**SERVICE BULLETIN**

**APPLICABILITY:** 2014MY XV Crosstrek Hybrid (HEV)

**NUMBER:** 07-81-14

**SUBJECT:** Revised Rear Combination Lamp to Prevent Condensation

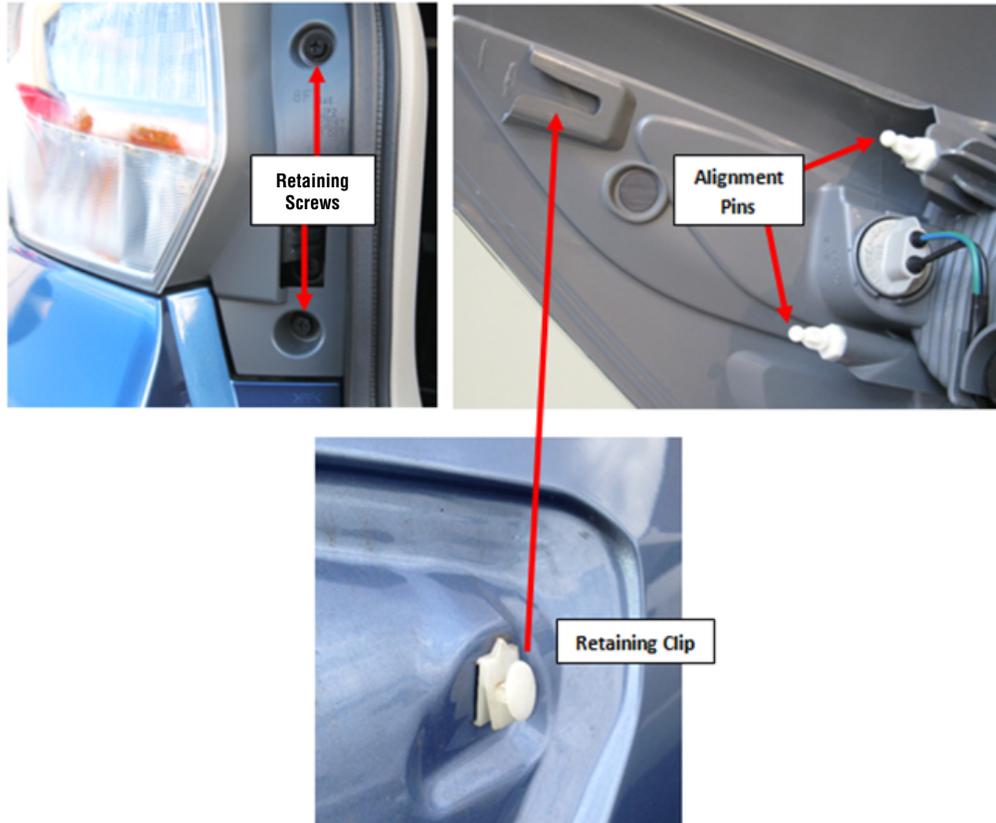
A revised rear combination lamp assembly has been developed which utilizes additional sealing material in four areas designed to prevent condensation from occurring on the inside of the housing. When performing this procedure, replace BOTH rear combination lamps at the same time.

PART NAME	NEW PART NUMBER	LOCATION
Lens & Body Compl.	84912FJ280	Right
	84912FJ290	Left

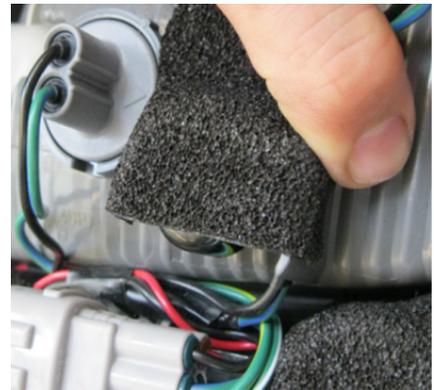
- The wiring harness assembly must be transferred over to the replacement combination lamp.
- **NOTE:** To properly position the harness into its retaining groove in the housing, the new additional sealing material just above the harness connector will need to be partially removed for access as shown in the photo sequence below. Do not disturb the material any more than necessary to properly position the harness.
- **CAREFULLY** lift/ peel the material up then, once the harness is tucked fully into the groove using a plastic trim tool, push the material back down into place.

- Tuck the LED harness past the sealing material into its corresponding retaining groove.
